[Docket No. FAA–2023–1650; Project Identifier AD–2023–00795–T; Amendment 39–22517; AD 2023–15–05]

Airworthiness Directives; The Boeing Company Airplanes

ACTION: Final rule; request for comments.

Figure 1 to paragraph (g) - Engine anti-ice AFM revision

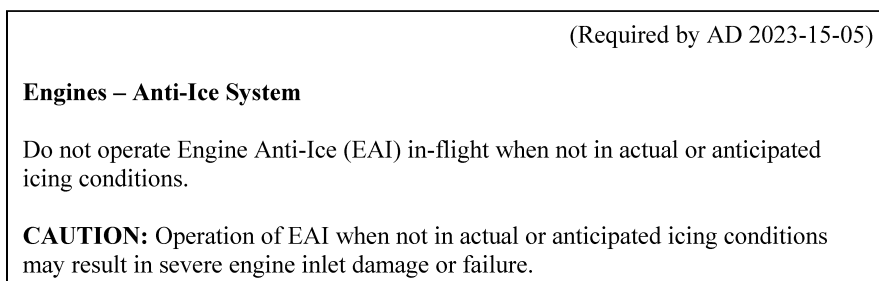
Within 15 days after the effective date of this AD: Revise the Limitations Section of the existing AFM to include the information specified in figure 1 to paragraph (g) of this AD. This may be done by inserting a copy of figure 1 to paragraph (g) of this AD into the existing AFM.
